T10: T10 Technical Committee (SCSI)

From: Charles Binford, Sun Microsystems, Inc., ([charles.binford@sun.com](mailto:charles.binford@sun.com))

Subject: Target Multiport Model

Figure X

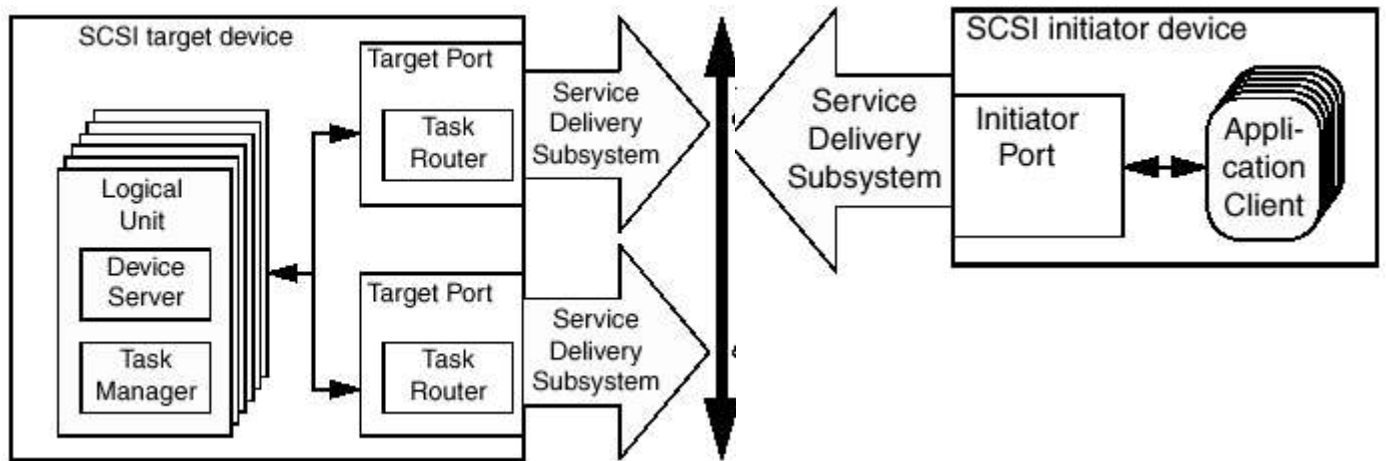
**The key question** this figure will answer is how many “initiators” does the target see? Should the target differentiate this from figure 21 above?

This subject came up at January's CAP meeting and it quickly became clear that there were different opinions/interpretations of how this configuration is viewed per SAM. Some felt that given the current transports defined for SCSI, that the target can and should figure out that the SCSI Initiator Port Name is the same at treat IOs delivered via either target port as if they were from the same SCSI initiator port.

Others (at least me! :-)) feel that should SAM require the target to treat this configuration as if there were two separate initiators.

For a redundant array controller configuration, having a device server view Figure X as two separate initiator ports allows for a much looser coupling of the task sets when TST=001b or Qerr=11b.
